Cairn Gorm – the beginner’s ski slope planning application (1)

Part 1. The Planning Application.

Planning Application - Piste smoothing and grading works -Beginners Base Area

Planning map courtesy of CMSL planning application, supporting information page 4

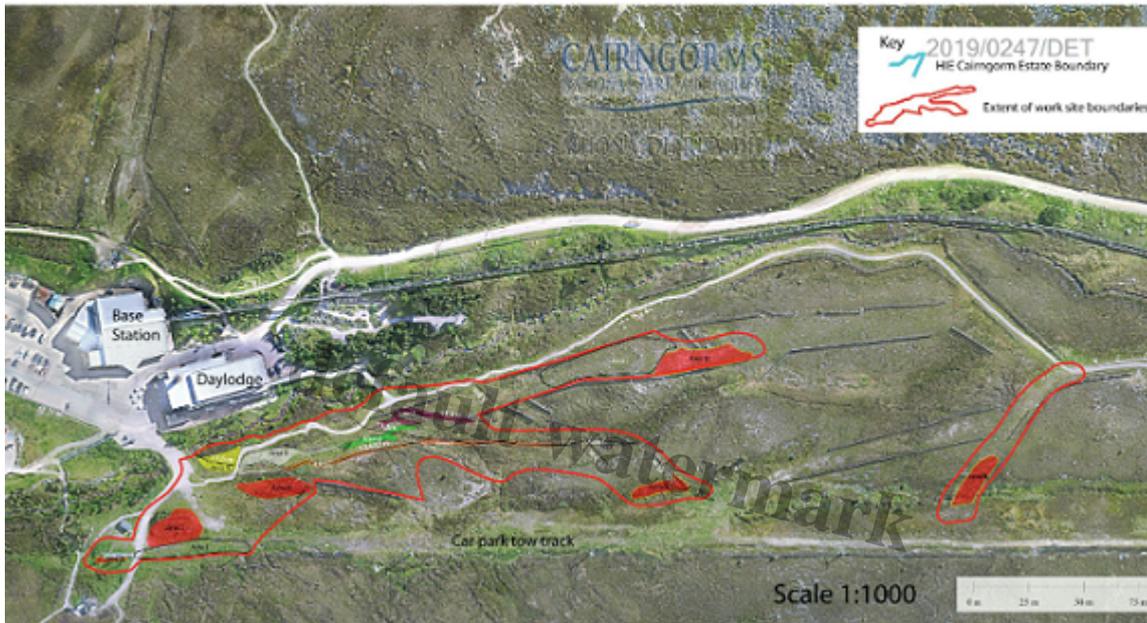
(1) The works site is described as being within the lower 300m of the slope. This is wrong as the access to Area N (see map above) is approximately 450m from the base of the Car park tow,

Site map on .25cm squared graph paper for area calculations â?? GIS would make this a lot easier!

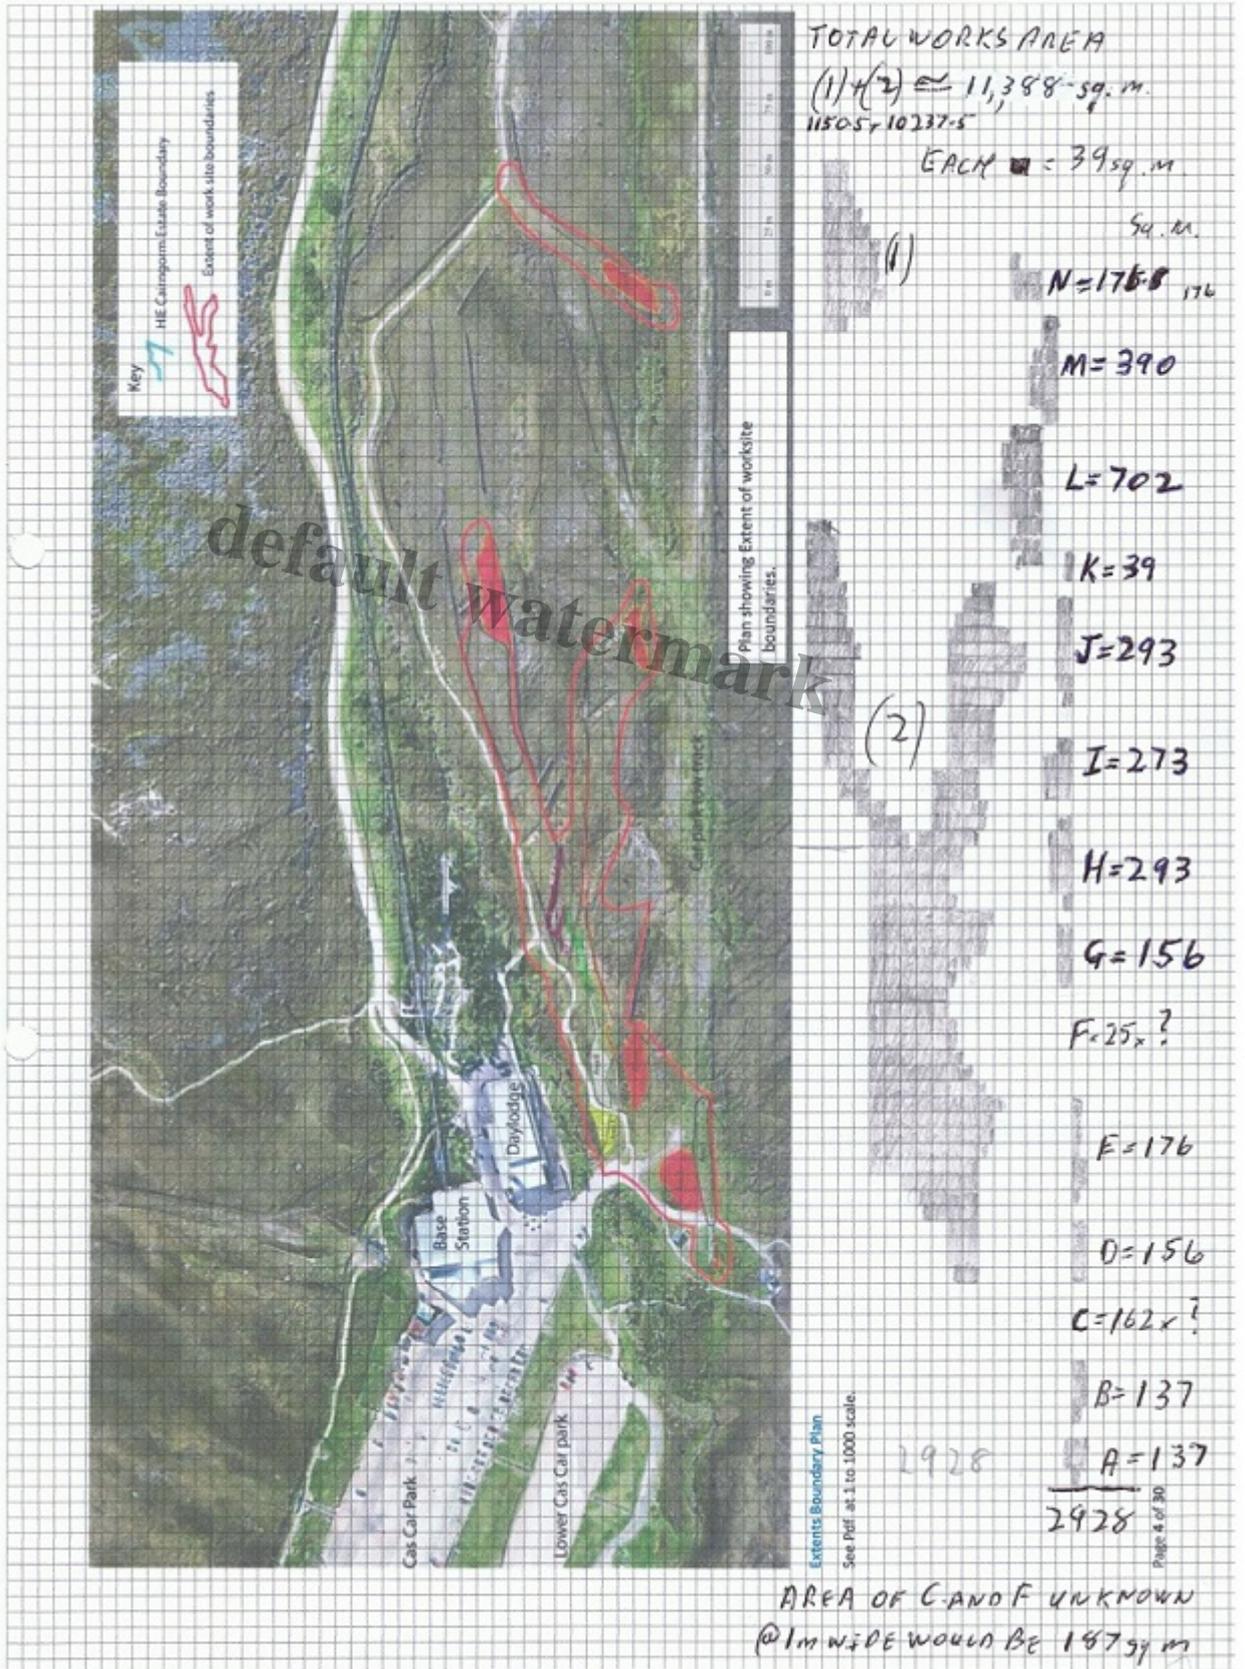
The site area, according to the application, is 0.93 hectares or 9,300 sq. m. There is no indication if this is the work area or the sum of the areas to be bulldozed! I have however worked out that it is the whole site, although by my calculations, which are approximate, the area is actually 11,388sq.m., while the area being bulldozed is over 2928sq.m.

Due to lack of clarity in the application documents, it is not possible to measure areas C & F. However, their total length is 187m. If we assume that a vehicle working on these areas creates a track 3m wide then the area of C + F is 561sq.m., bringing the total to 3489sq.m.
